TO: Mr. Jim Rioux, Project Manager, City of Olympia
FROM: David Johnson, PE
DATE: January 9, 2020
RE: **SEPA Response Summary**
Water Street Lift Station Generator Replacement
Olympia, Washington
Project No. 0258060.010.011

SEPA Response Summary

Ecology SEPA Comment Letter (5/9/19)

Thank you for the opportunity to comment on the determination of nonsignificance for the Water Street Lift Station Generator Replacement Project (19-1127) proposed by City of Olympia Public Works Department. The Department of Ecology (Ecology) reviewed the environmental checklist and information provided and has the following comment(s):

EXTERIOR DEMOLITION AND TESC PLAN AND DETAILS

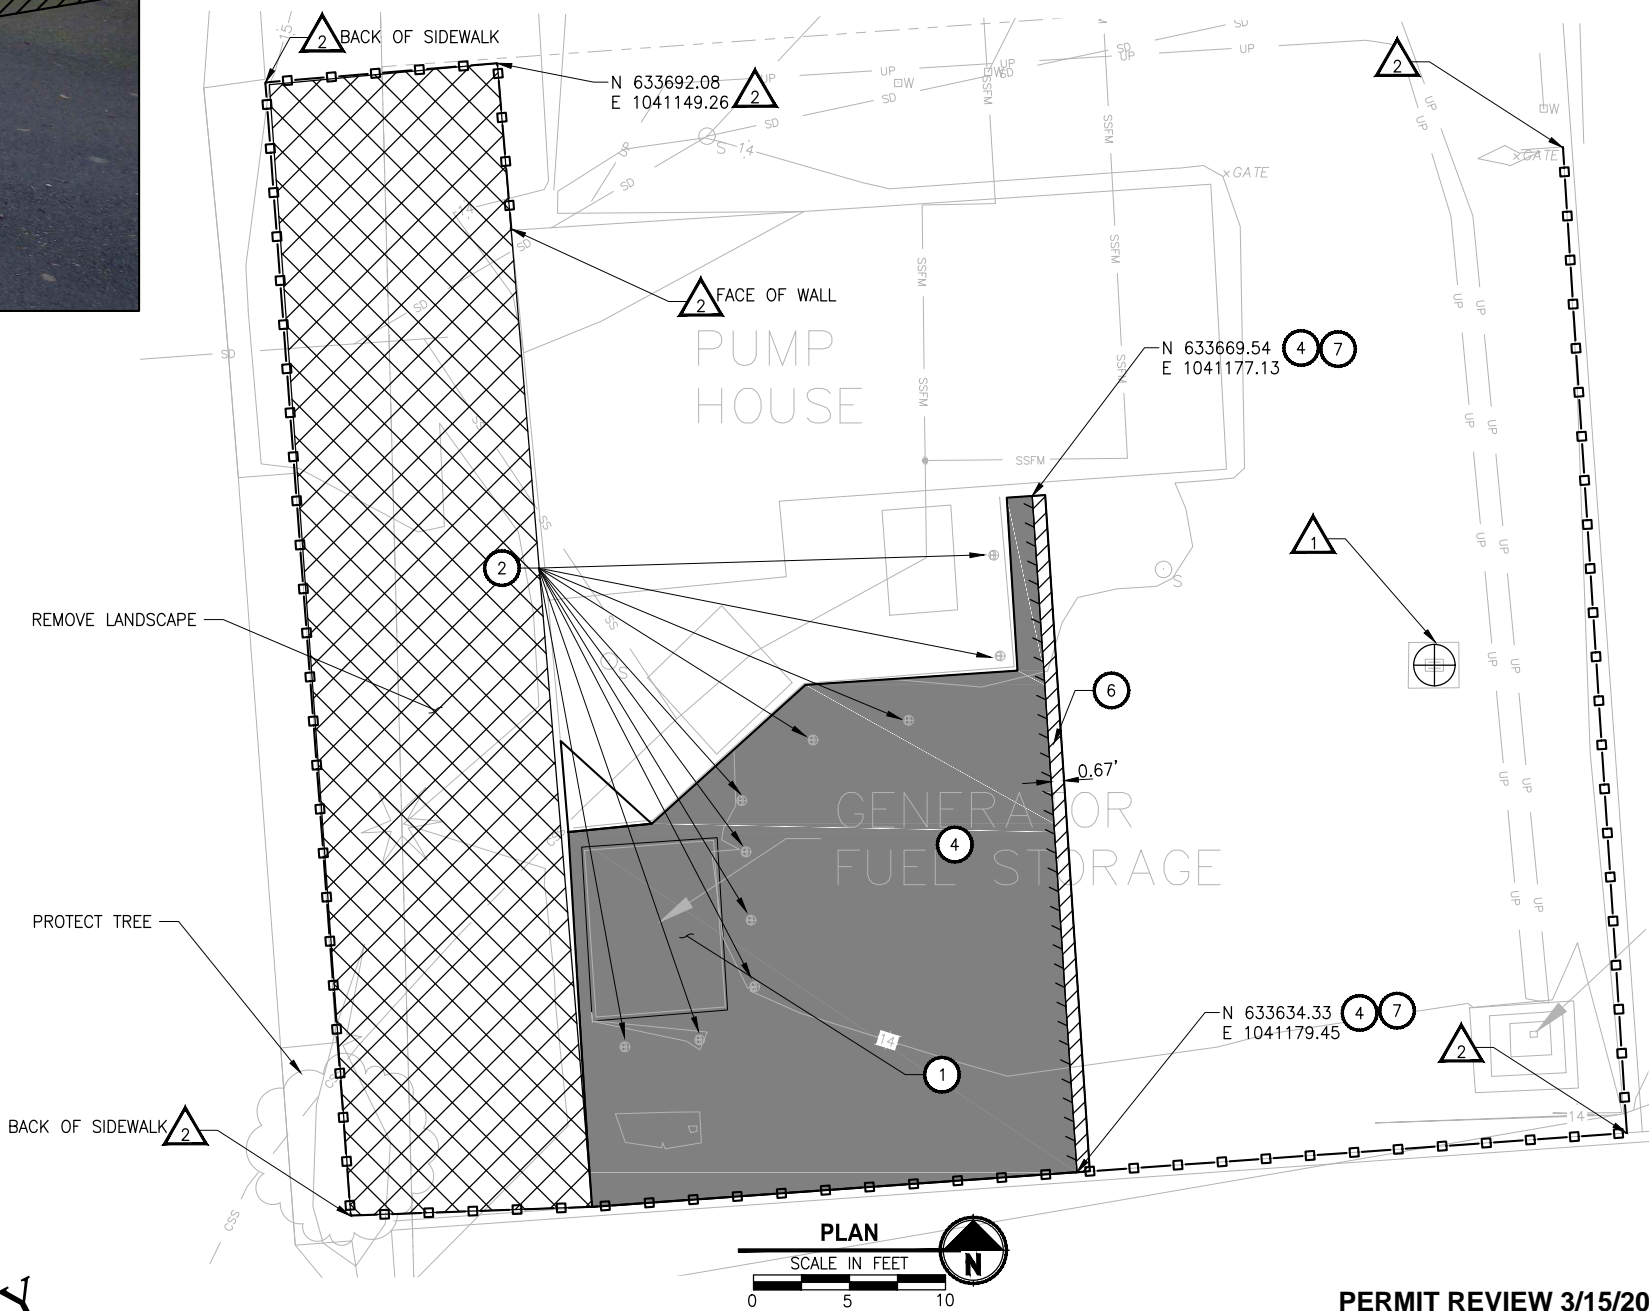
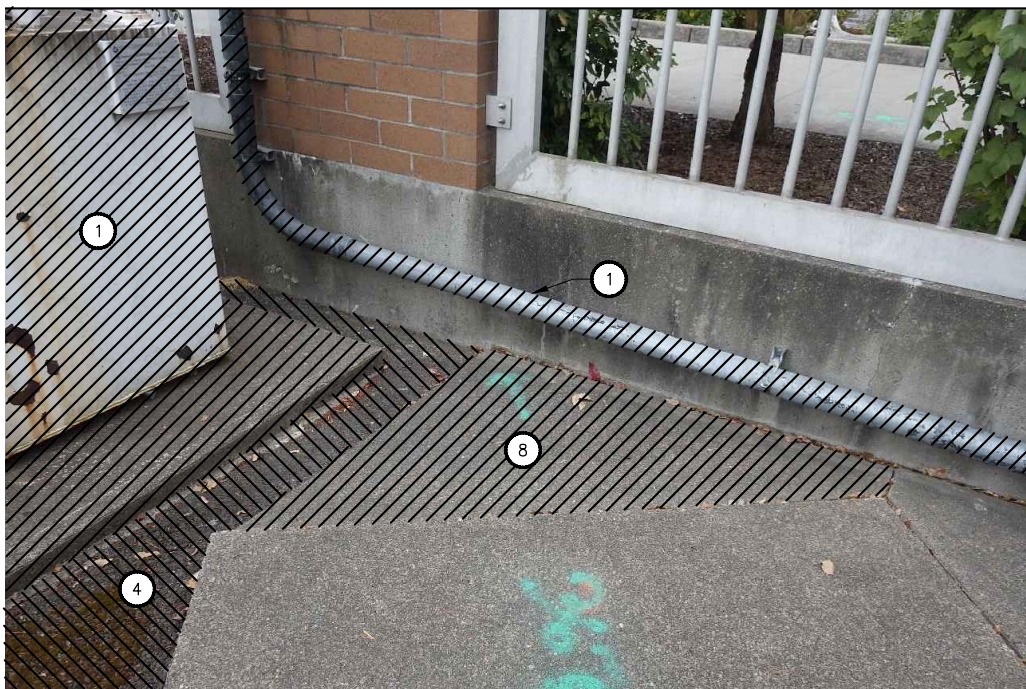
- *Best management practices should be required to ensure that contaminated soil, sediment or water runoff from this project does not enter Budd Inlet.*

Ecology Comment: *Erosion control measures must be in place prior to any clearing, grading, or construction. These control measures must be effective to prevent stormwater runoff from carrying soil and other pollutants into surface water or storm drains that lead to waters of the state. Sand, silt, clay particles, and soil will damage aquatic habitat and are considered to be pollutants.*

LAI Response: BMPs will be outlined in the Environmental Media Management Plan and implemented to ensure that contaminated soil, water runoff, and groundwater from the Site does not enter Budd Inlet. The Project will not encounter Site sediment. Temporary erosion and sediment

controls (TESC) will be implemented in accordance with the TESC Plan shown on sheet D1 (90 percent Design Plans) by the contractor so that no contaminated soil and water runoff from the project will enter Budd Inlet.

LAI Response: Based on LAI review of the scope of work, appropriate TESC Plans are planned to be implemented for the project based on the 90 percent Design Drawings. Based on the current proposed Project, the Ecology requirements for coverage under the Construction Stormwater General Permit (CSWGP) will not be triggered.

INTERIOR DEMOLITION
DETAILS

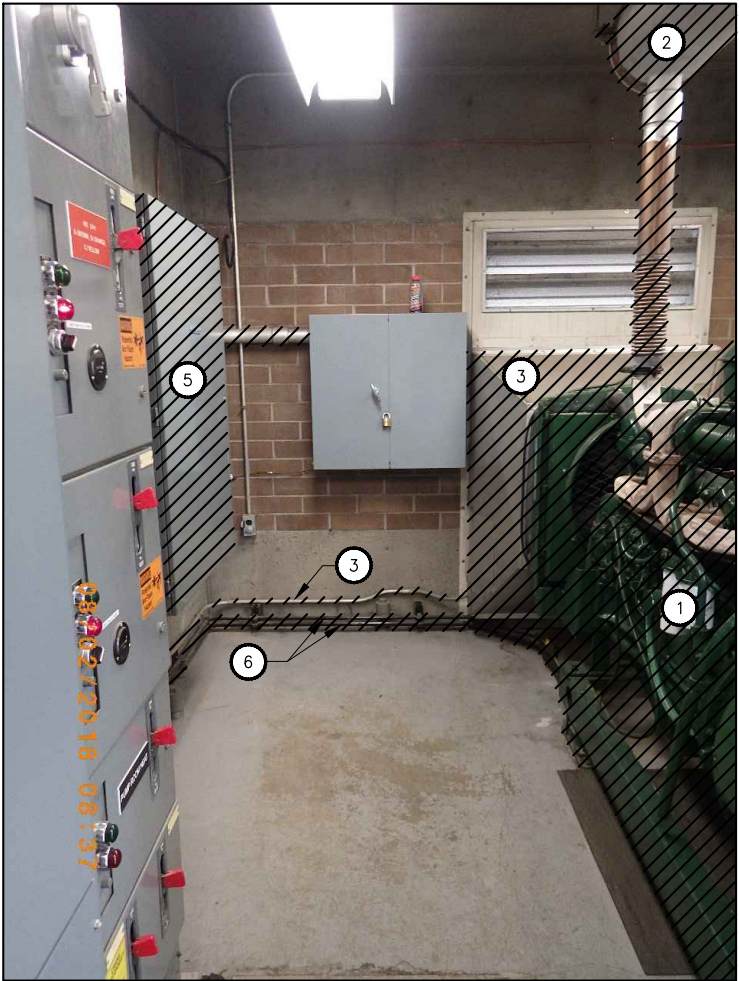
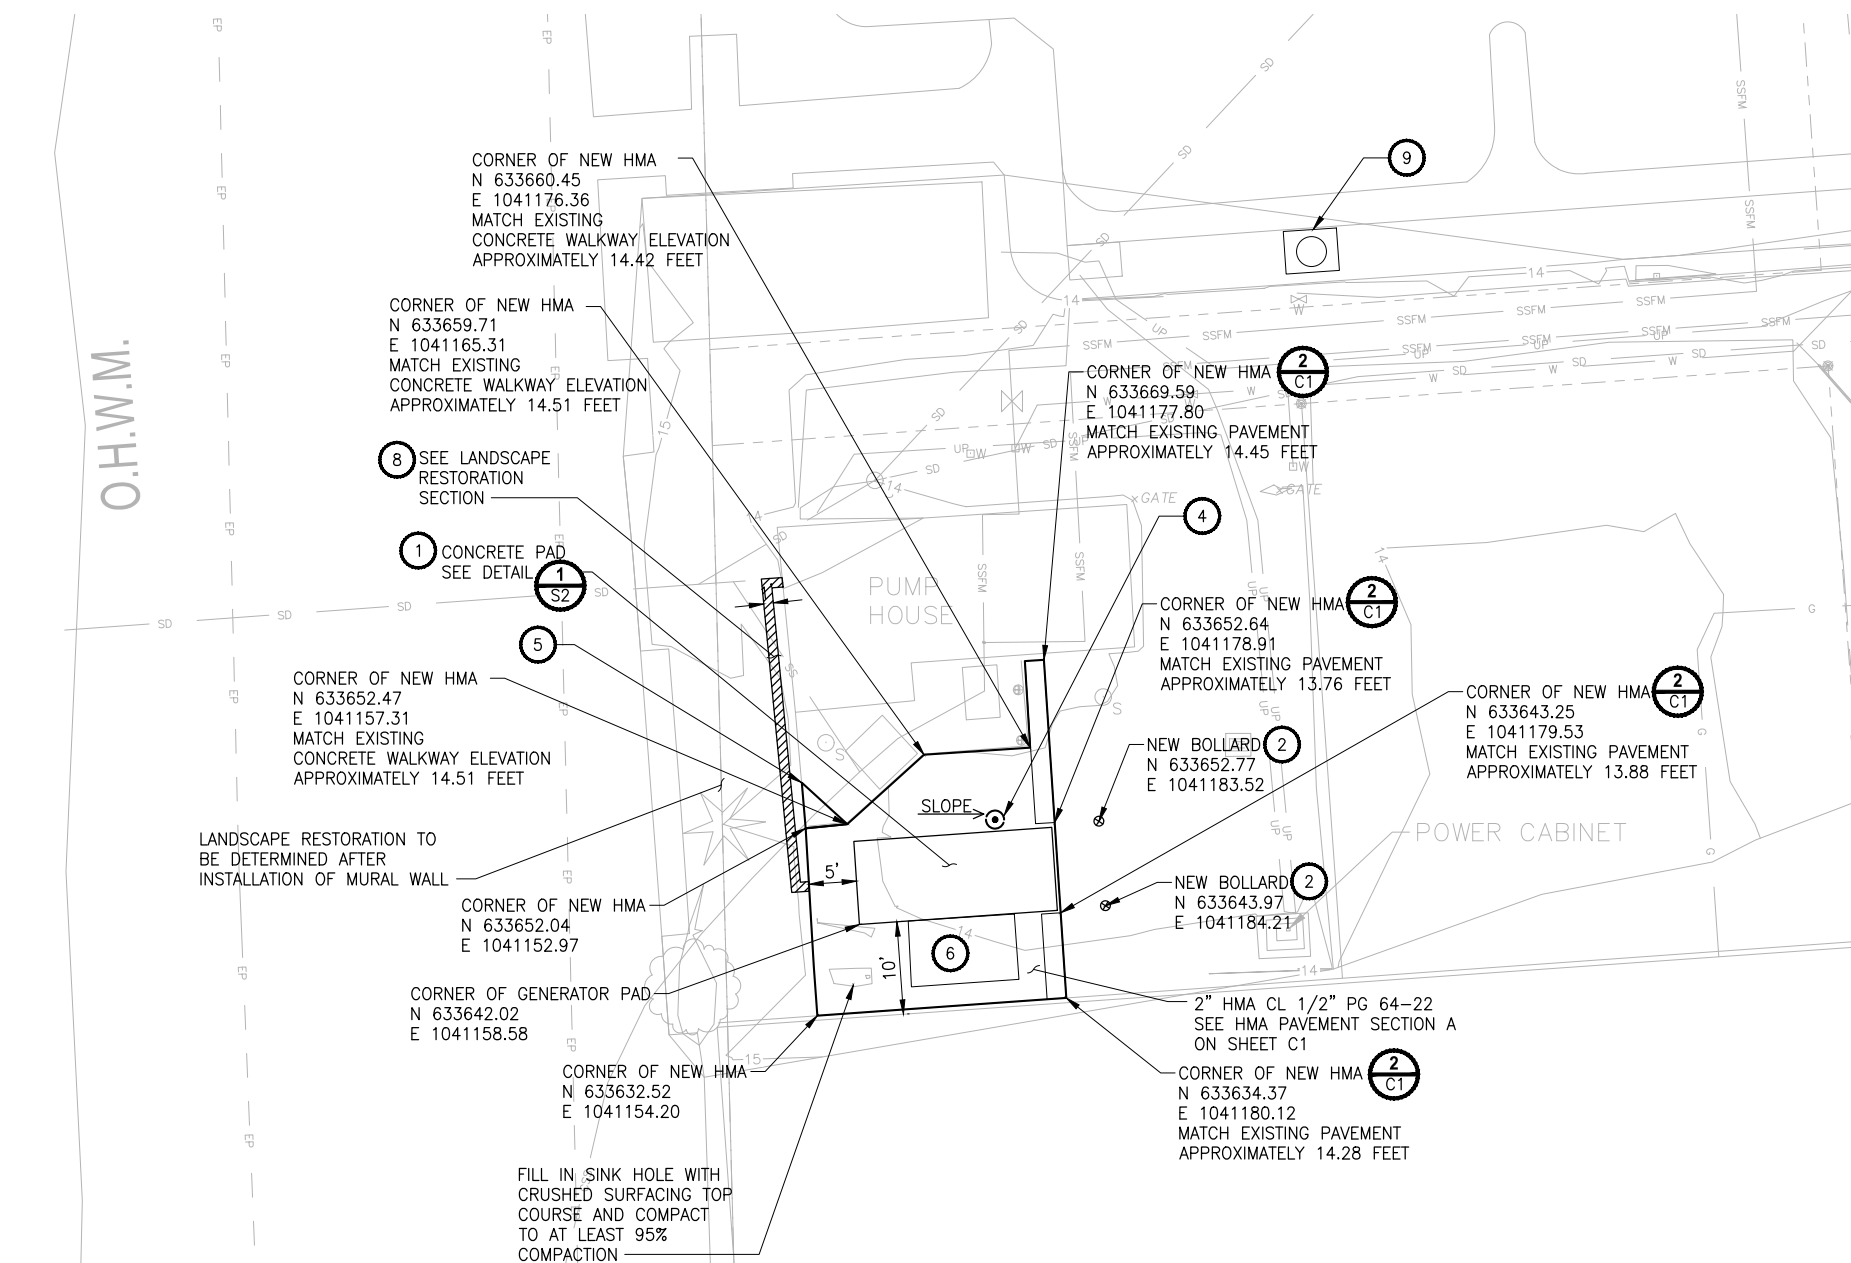
Ecology Comment: *The applicant proposes to demolish an existing structure(s). In addition to any required asbestos abatement procedures, the applicant should ensure that any other potentially dangerous or hazardous materials present, such as PCB-containing lamp ballasts, fluorescent lamps, and wall thermostats containing mercury, are removed prior to demolition. Also, be aware that PCBs are increasingly being found in caulking and paint. It is important that these materials and wastes are removed and appropriately managed prior to demolition. It is equally important that demolition debris is also safely managed, especially if it contains painted wood or concrete, treated wood, or other possibly dangerous materials.*

LAI Response: The Project includes limited exterior and interior demolition to remove the existing generator as shown on the 90 percent Design Drawings Sheet D1 and D2. Based on LAI review of the materials to be demolished, a Hazardous Building Materials Survey (HBMS) is recommended to be performed by the City or contractor selected for construction of the replacement generator prior to initiating demolition activities.

ELECTRICAL SITE PLAN
E2

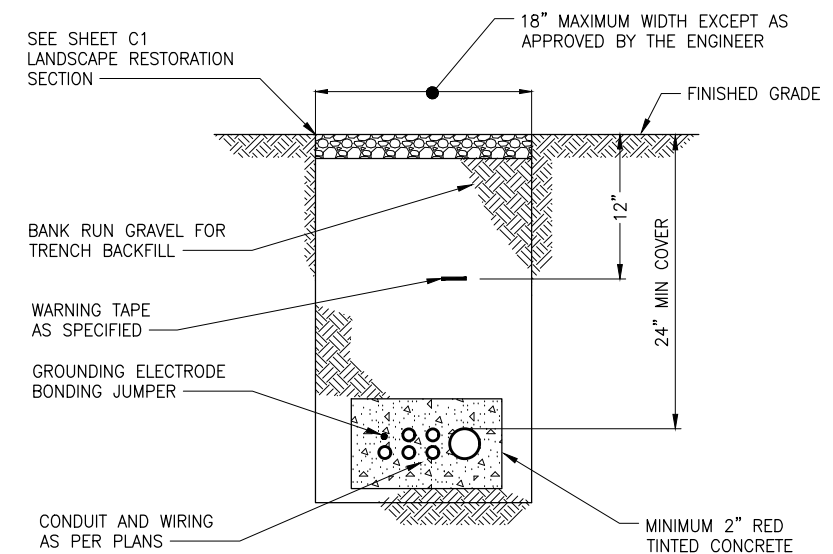
- *Best management practices should be required to reduce human exposure to the currently unknown levels of contamination. During the project, soil, dust, and water from the toxic site should be considered contaminated and handled in accordance with guidance contained in Ecology Toxic Cleanup Program Publication 10-09-057, Guidance for the Remediation of Petroleum Contaminated Sites, Revised June, 2016.*

LAI Response: BMPs will be detailed in the Environmental Media Management Plan to be prepared by LAI for use during the project by the City. BMPs will be implemented to reduce human exposure to the currently unknown levels of contamination during the course of Project construction. The current Project scope of work includes limited demolition and shallow excavations to construct the replacement generator slab foundation pad and trenching of equipment electrical and control wiring. The generator pad foundation will be constructed to a planned depth of 18-inches below ground surface (bgs) in accordance with Sheet S2 of the 90 percent design drawings. The electrical and control conduit trenches will be limited to an approximate depth of 36 inches in accordance with Detail 1 on Drawing E2 of the 90 percent design drawings.
